Your Ref
HS/OA/15/00168

Our Ref
PLAN-009157
Date

Proposal: Outline application for the erection of up to 210 dwellings (25% affordable) with associated open space, play areas, landscaping and access.
Site: Former The St Leonards Academy, Darwell Campus, Darwell Close, St Leonards-on-sea, TN38 9JP.
HS/OA/15/00168

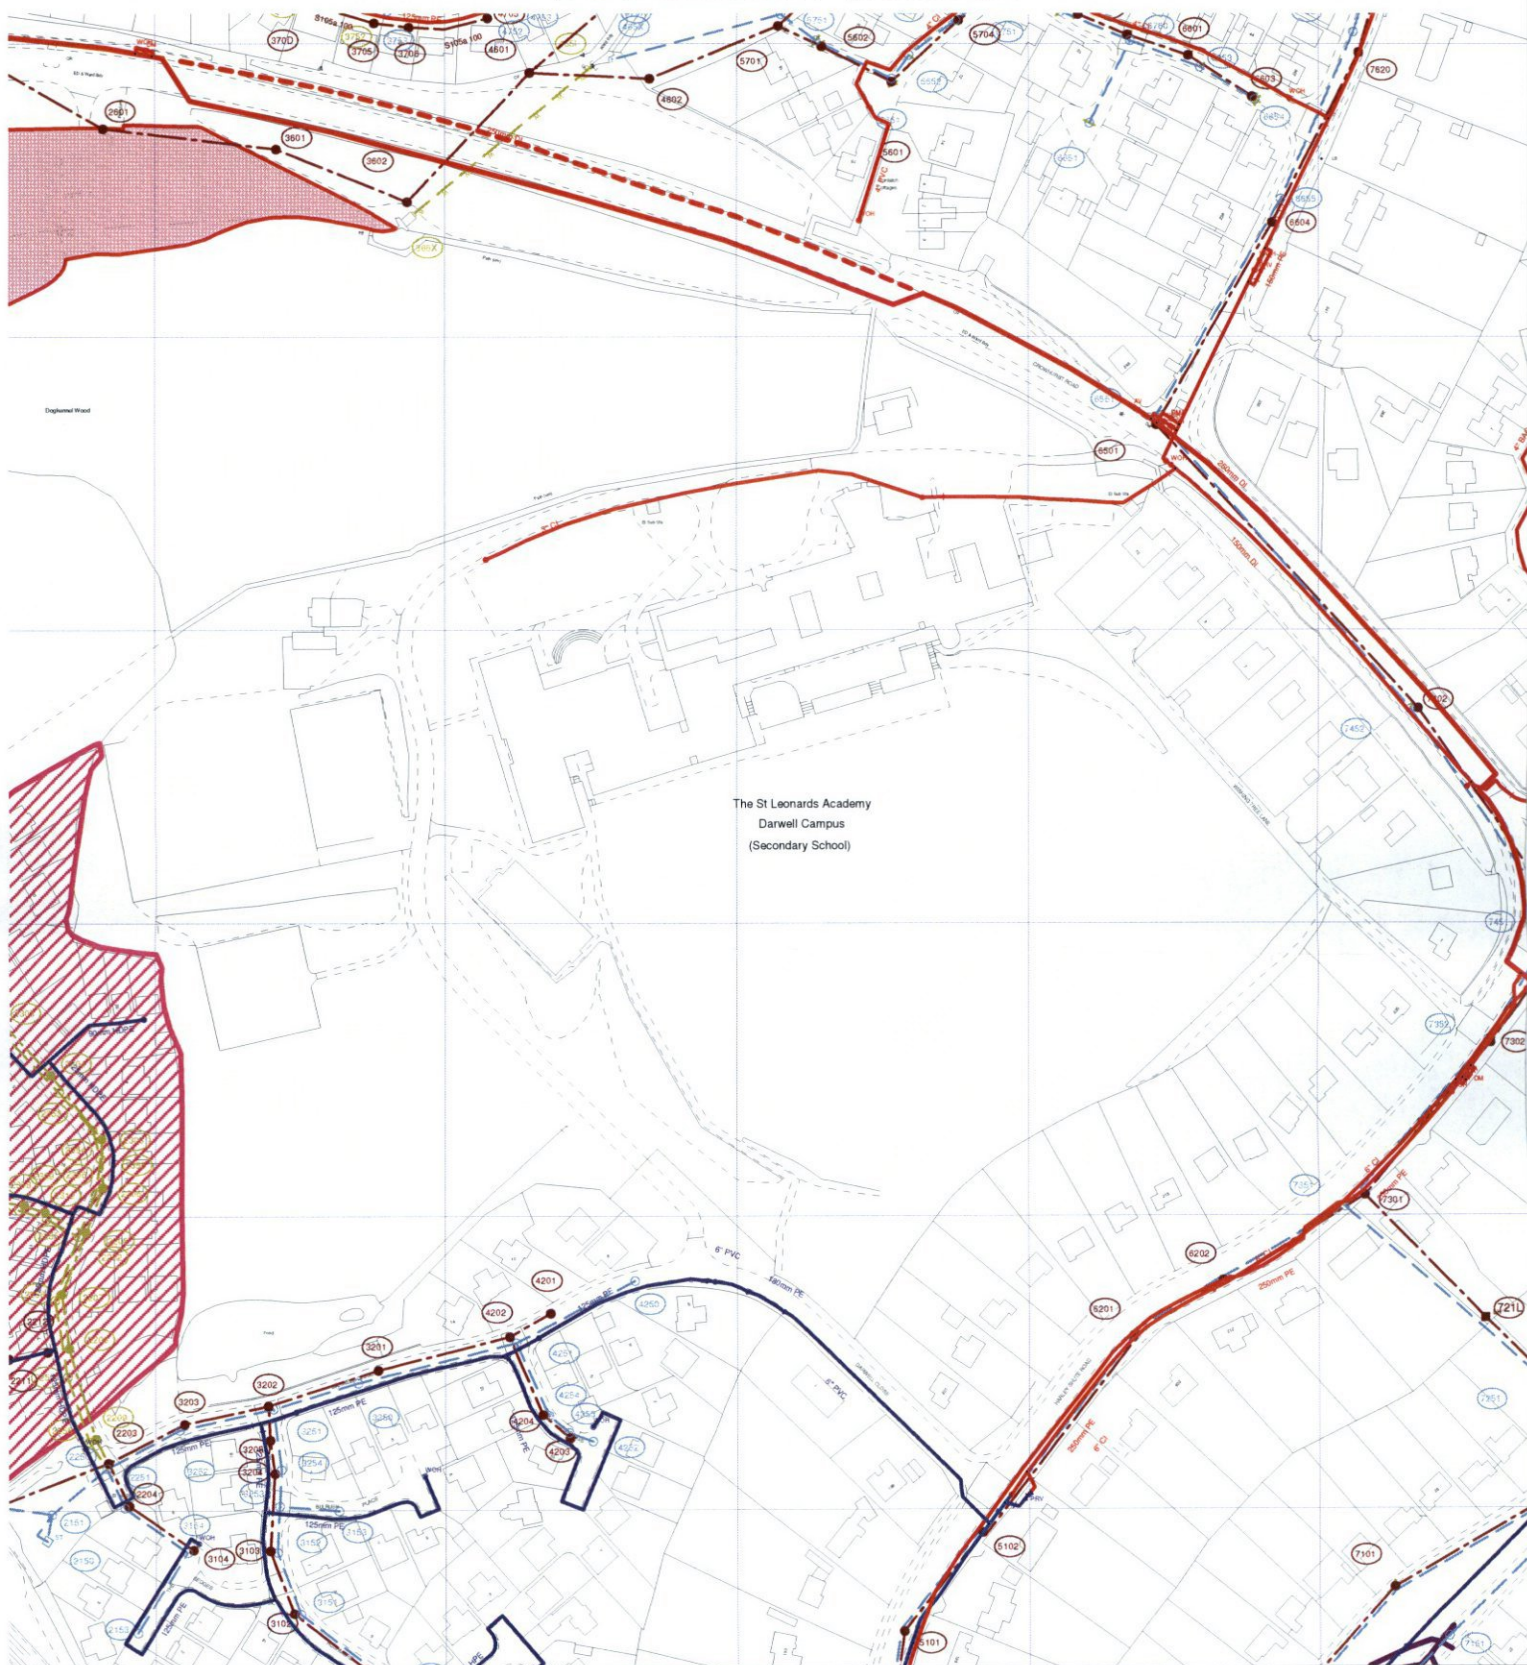
Please find attached a plan of the water main records showing the approximate position of a public water distribution main crossing the site. The exact position of the public water main must be determined on site by the applicant before the layout of the proposed development is finalised.

It might be possible to divert the public water main, so long as this would result in no unacceptable loss of hydraulic capacity, and the work was carried out at the developer's expense to the satisfaction of Southern Water under the relevant statutory provisions. Consents will be necessary for excavations in proximity to water mains.

In order to protect water apparatus, Southern Water requests that if consent is granted, a condition is attached to the planning permission. For example: "The developer must agree with Southern Water, prior to commencement of the development, the measures to be undertaken to divert / protect the public water supply main."
